Addendum #2

Project: 2024 – Fishers Elementary School Addition & Renovations

ADDENDUM NO: 2

PROJECT: 2024 – Fishers Elementary School Addition and Renovations

DRAWING NUMBER A802C PROJECT NUMBER

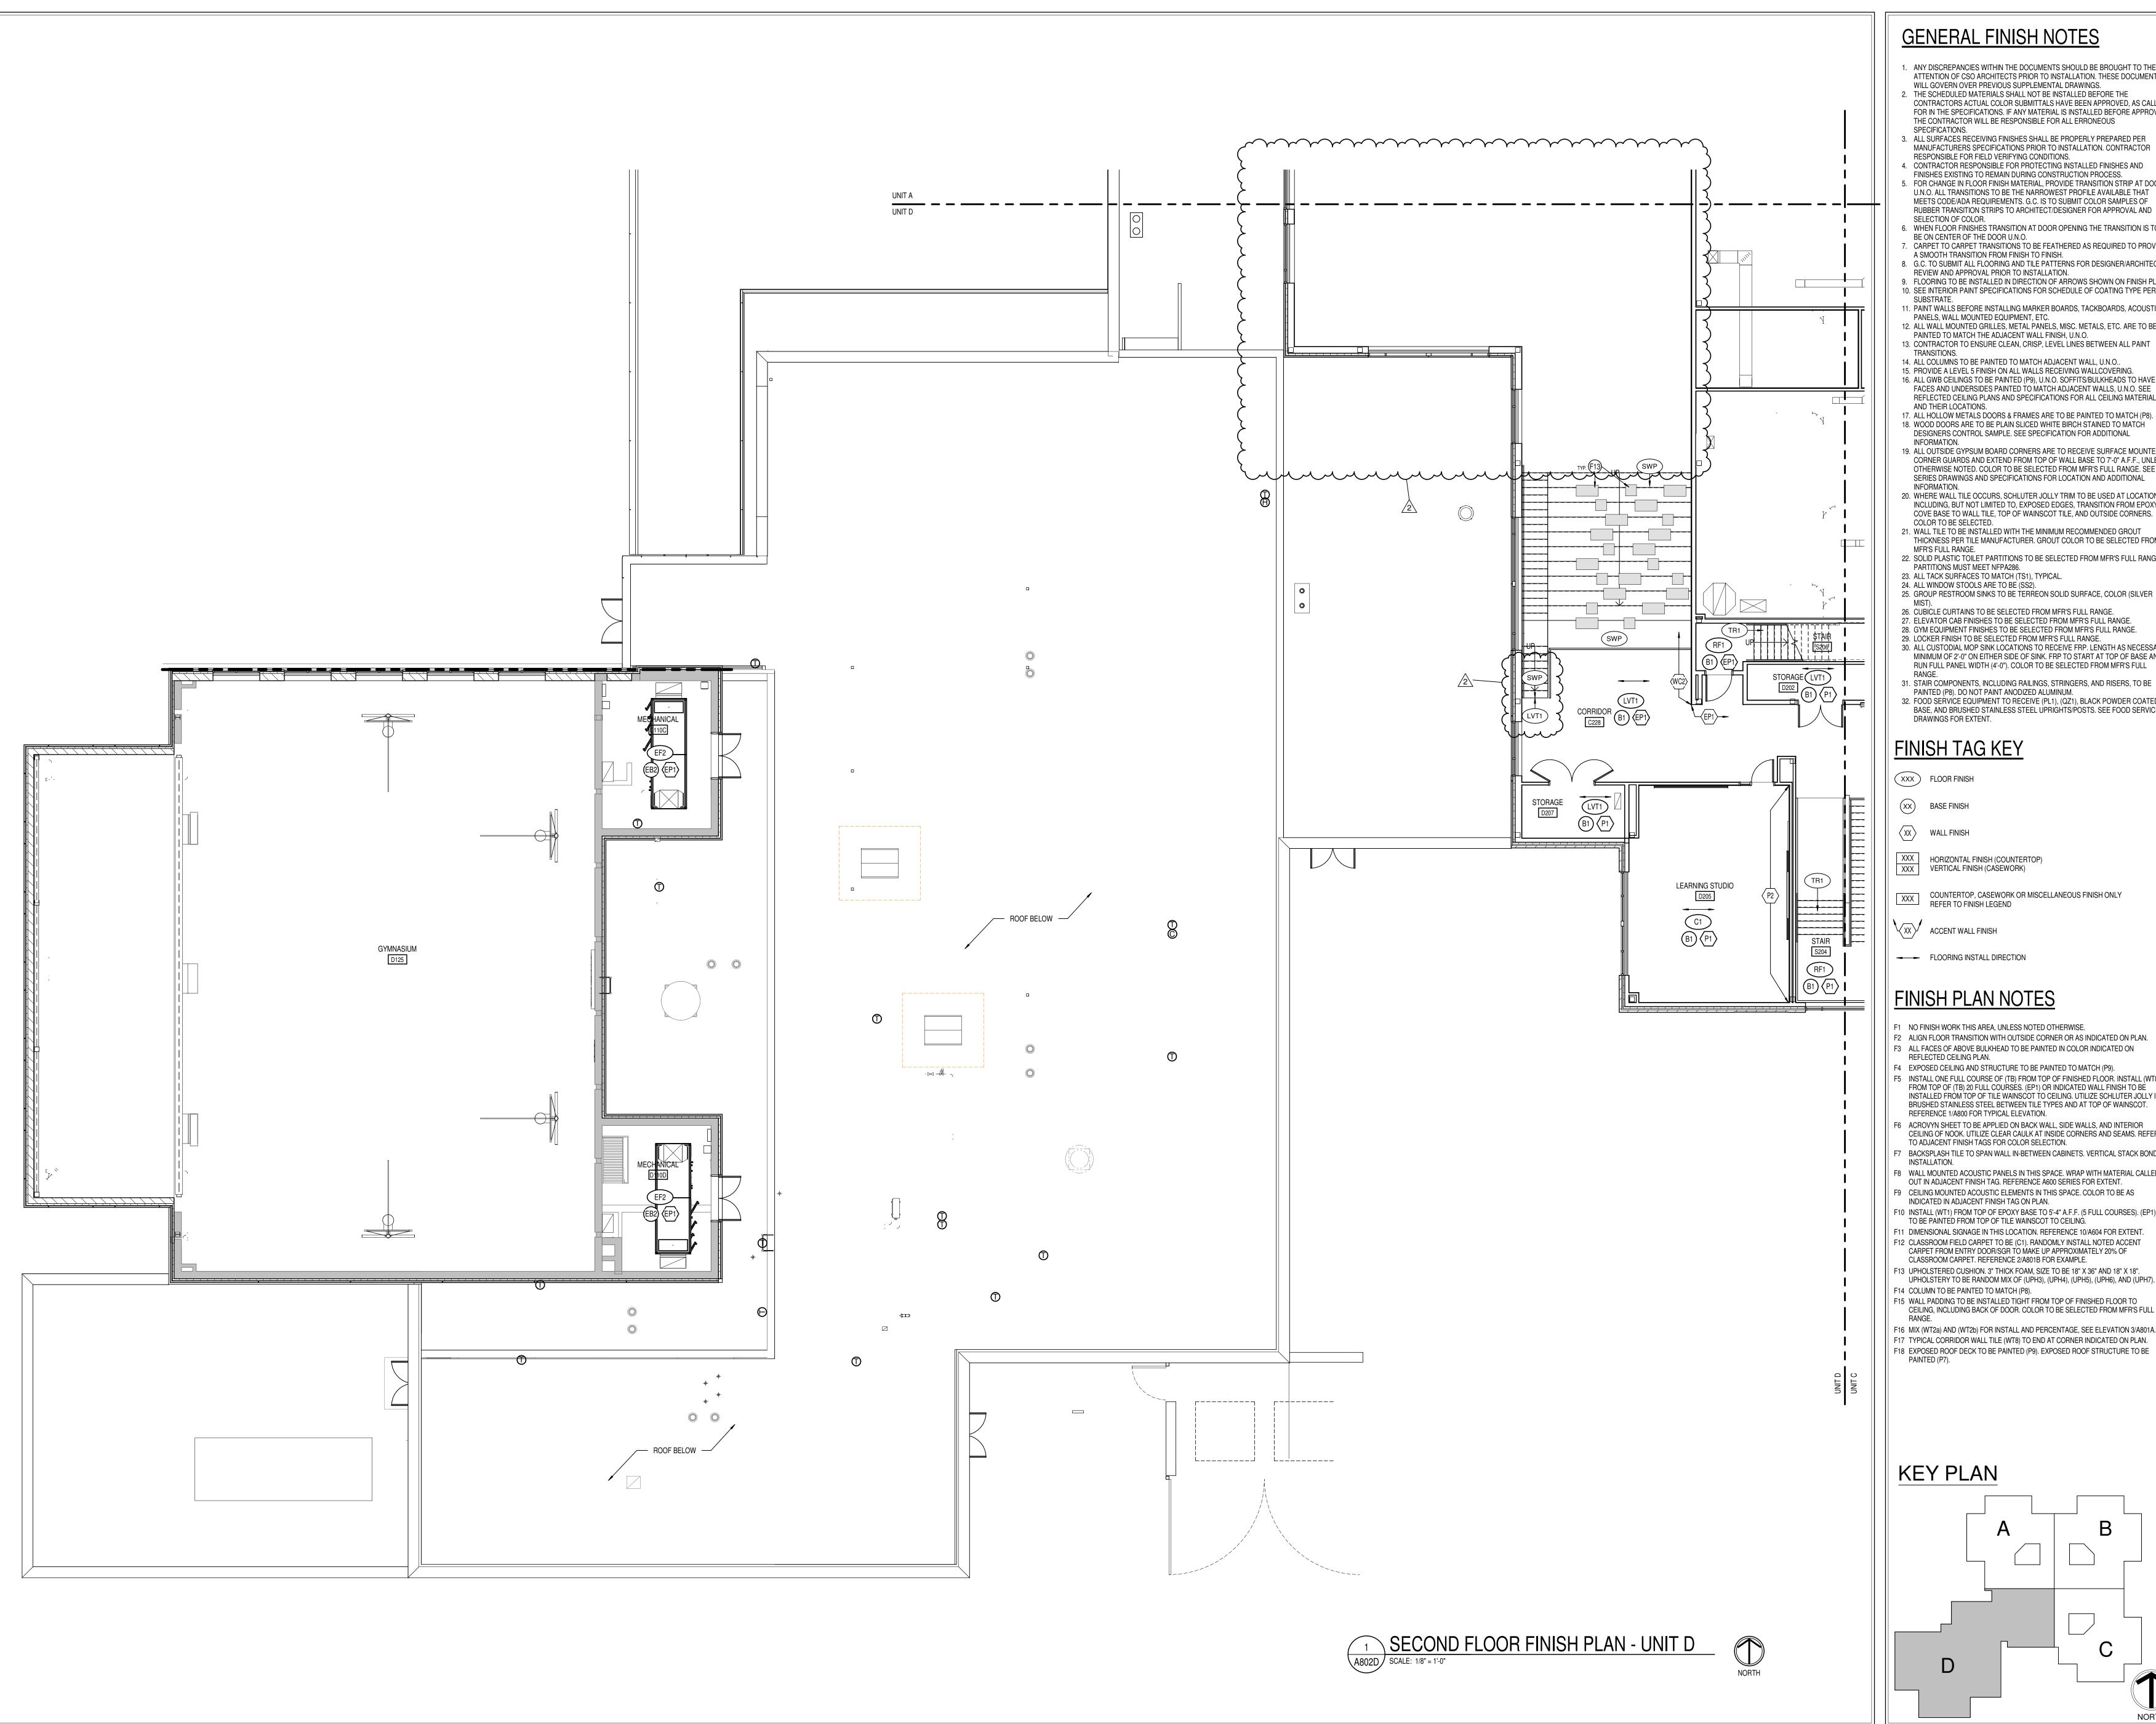
- A. Shifted callout tags for clarity
- B. Added elevation tag to 2/A802C
- C. Added F3 finish tag to CORRIDOR B226

A802D PROJECT NUMBER

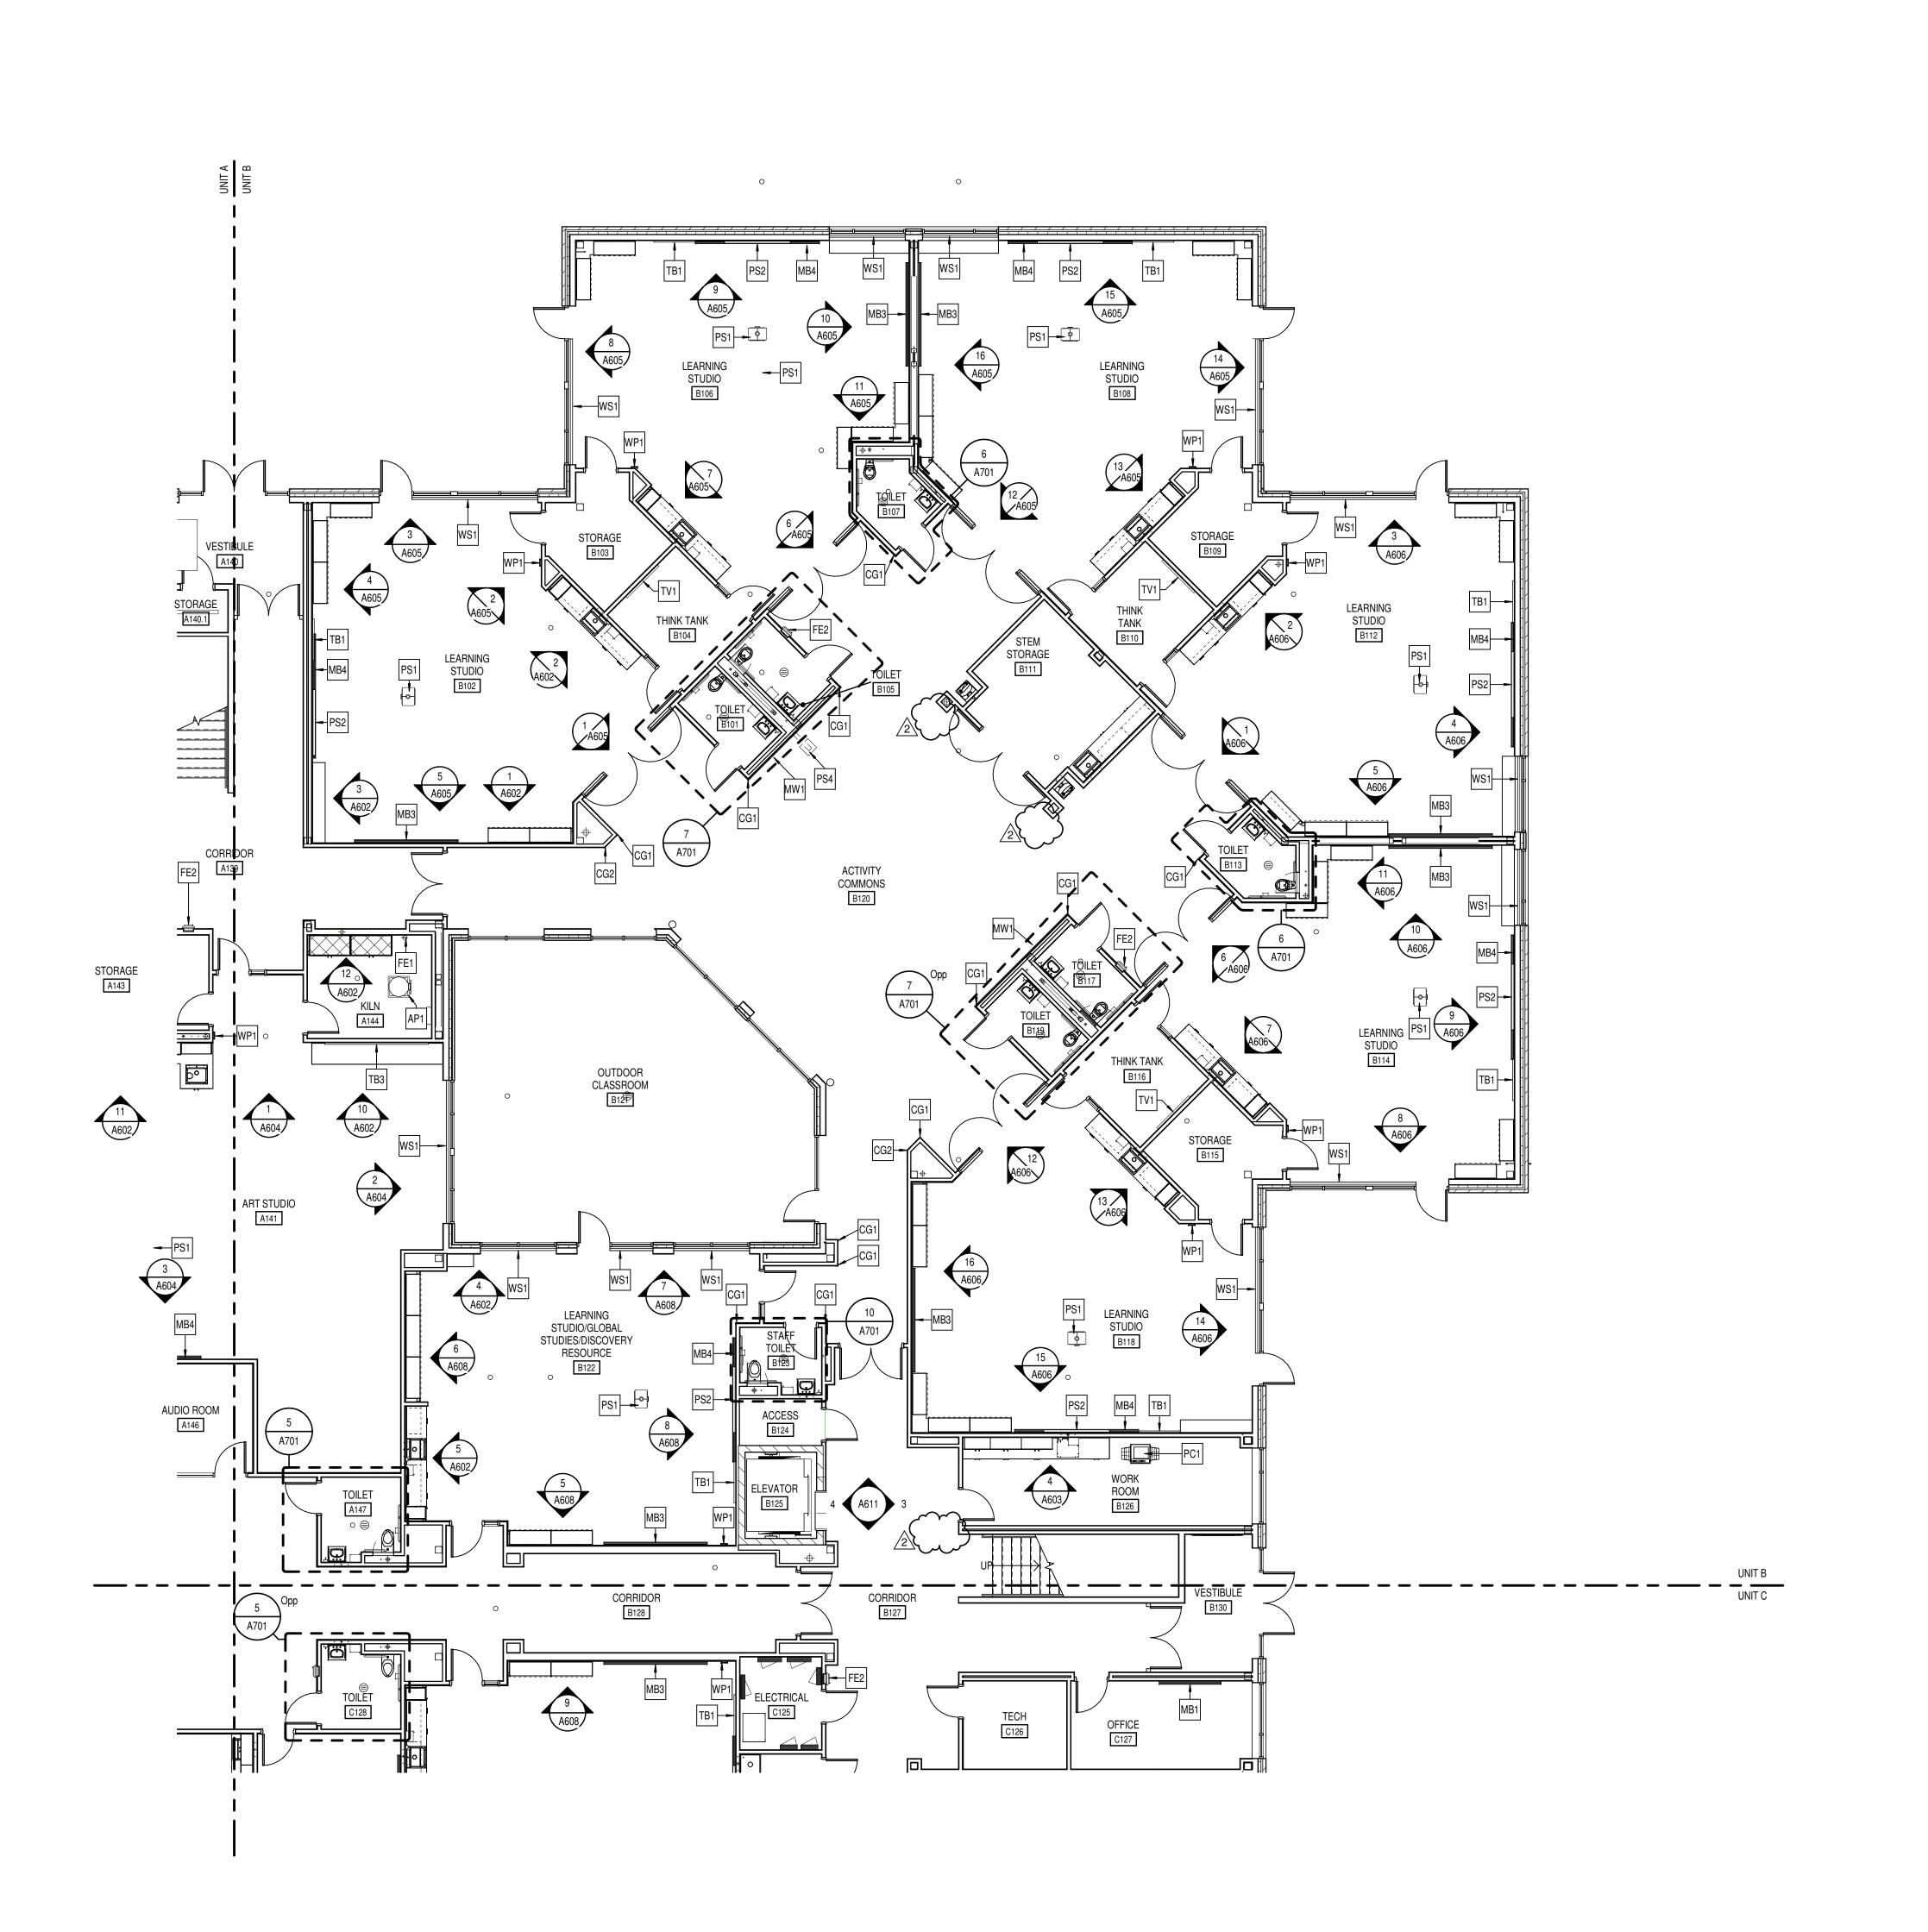
- A. Removed ceiling mounted acoustic flap wings for clarification
- B. Added floor transition tags in CORRIDOR C228

SECOND FLOOR EQUIPMENT PLAN - UNIT A

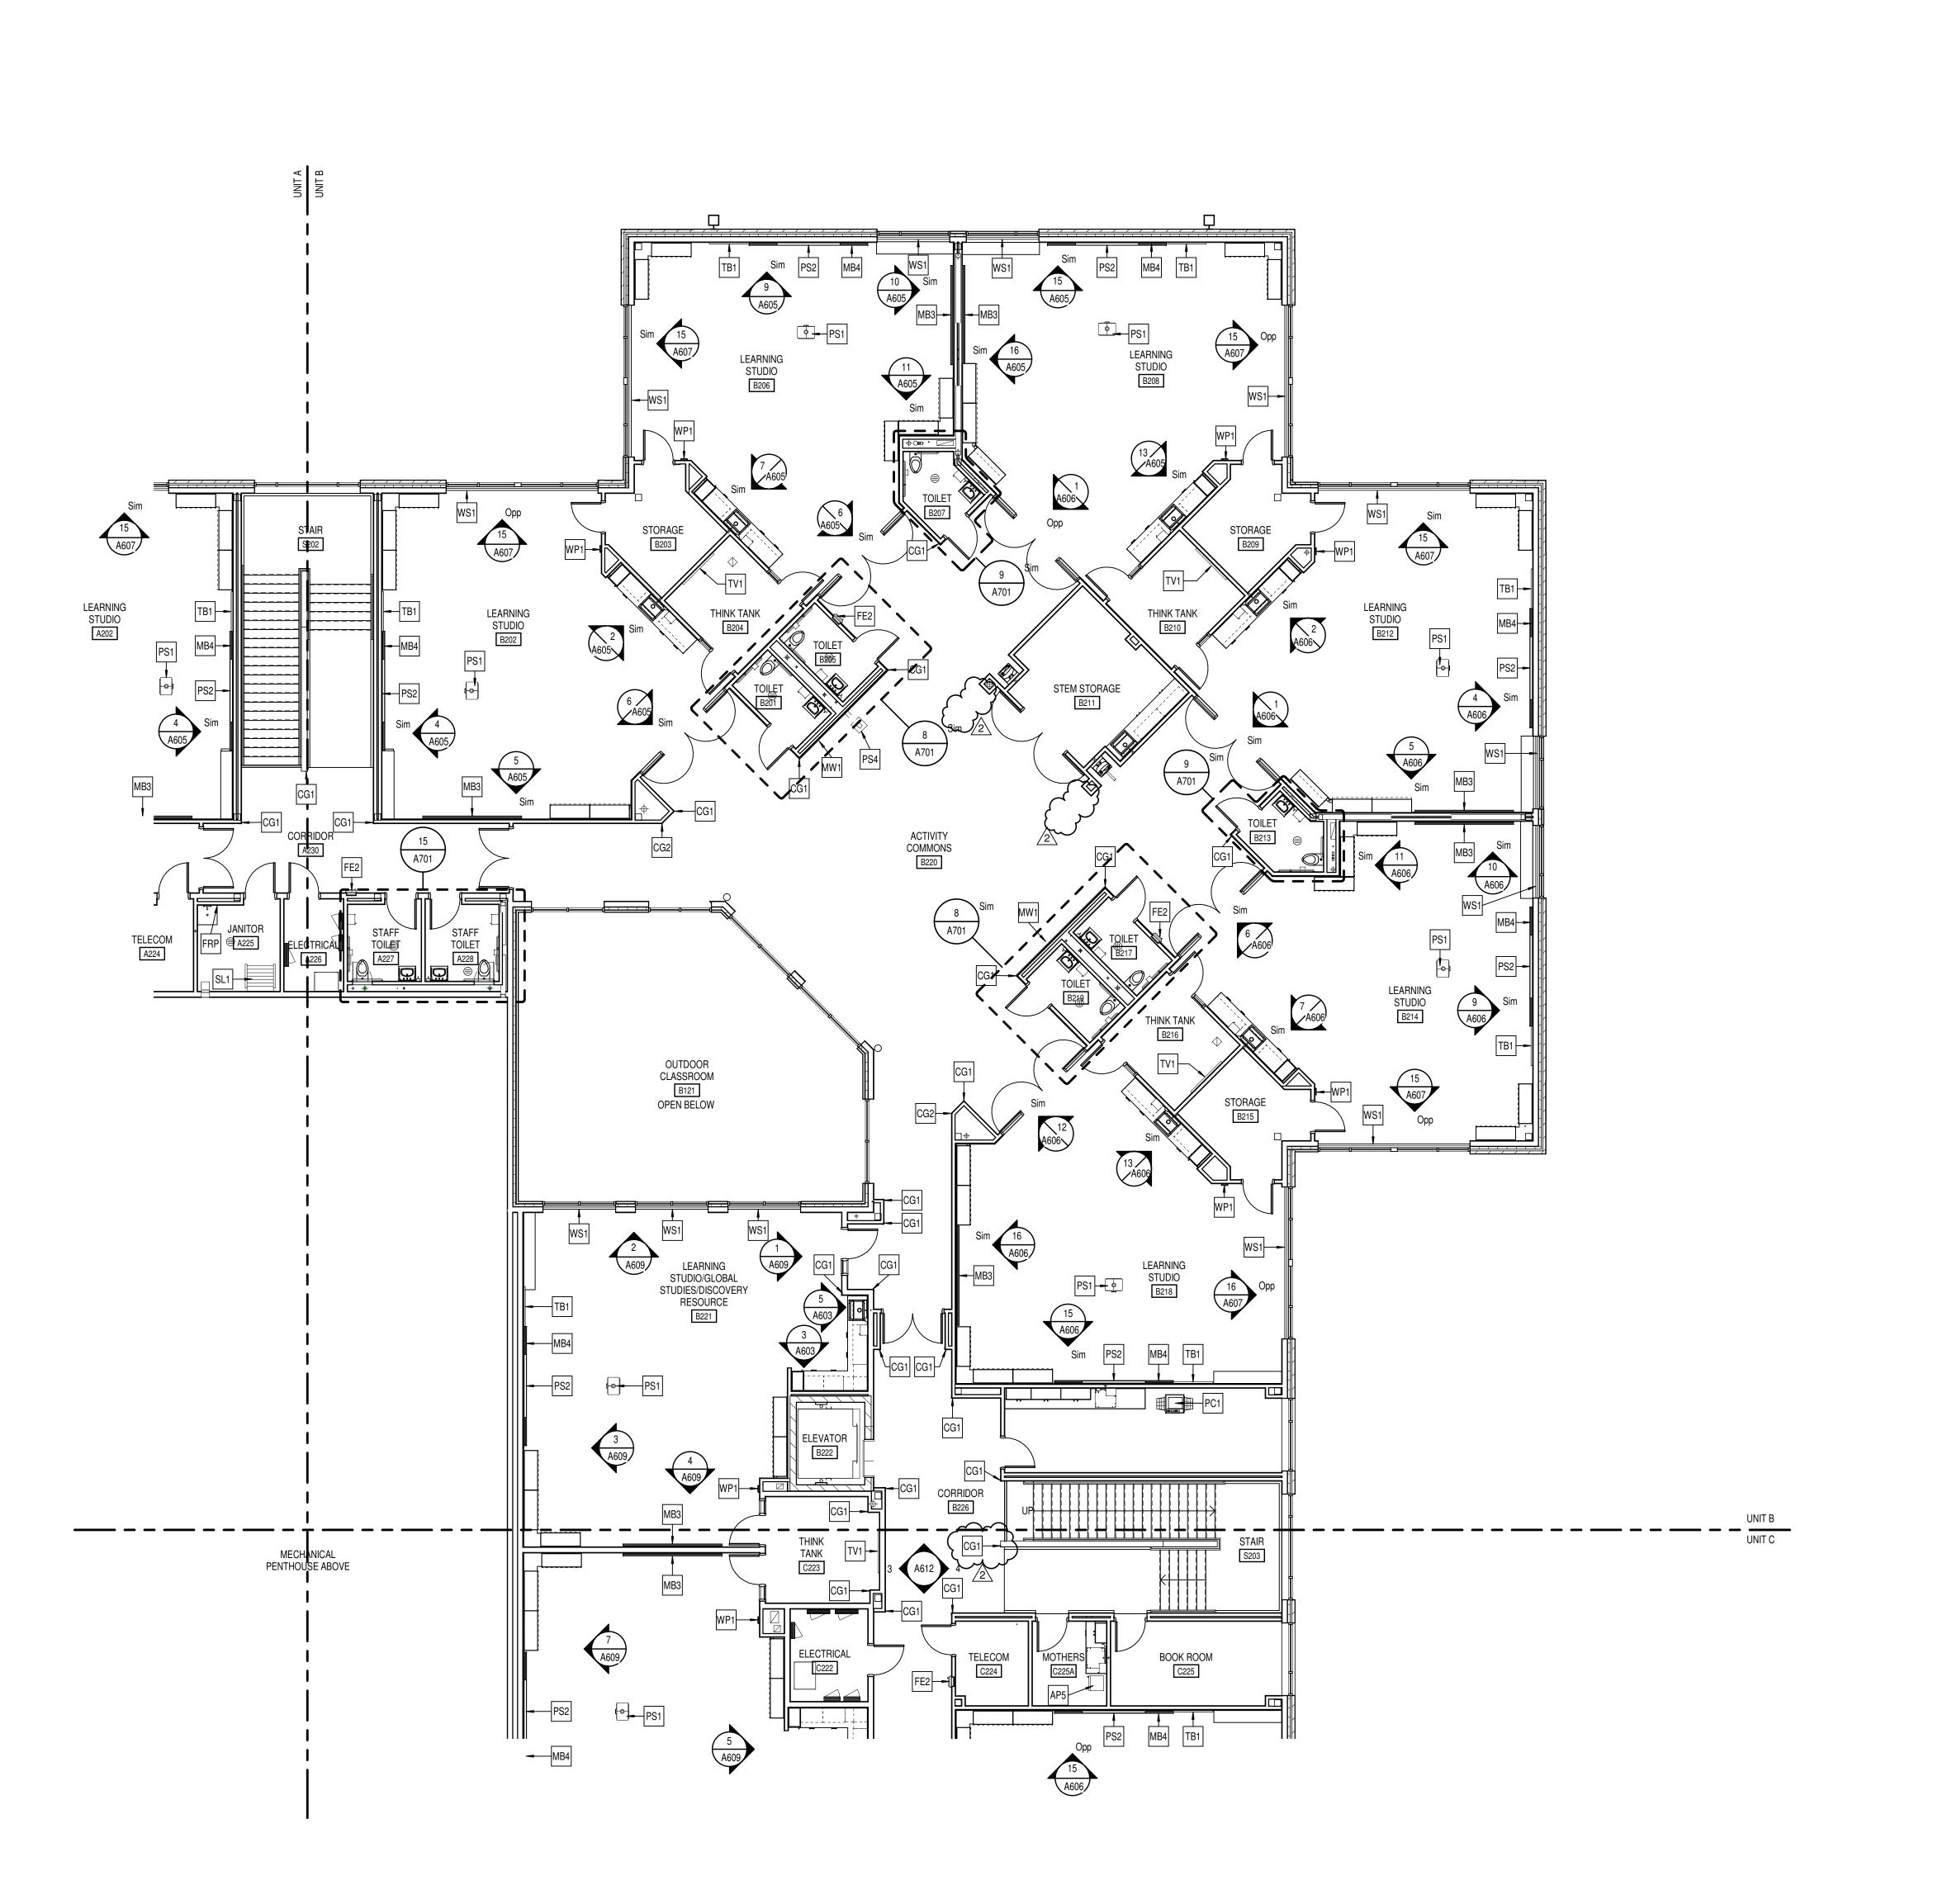
- A. Removed corner guard from ACTIVITY COMMONS A220
- B. Added corner guard to CORRIDOR A230
- 4.38 <u>A902B SECOND FLOOR EQUIPMENT PLAN UNIT B</u>
  - A. Removed corner guard from ACTIVITY COMMONS B220
  - B. Added corner guard to CORRIDOR B226
- 4.39 <u>A902C SECOND FLOOR EQUIPMENT PLAN UNIT C</u>
  - A. Removed corner guard from ACTIVITY COMMONS C220
  - B. Added corner guard to CORRIDOR C228
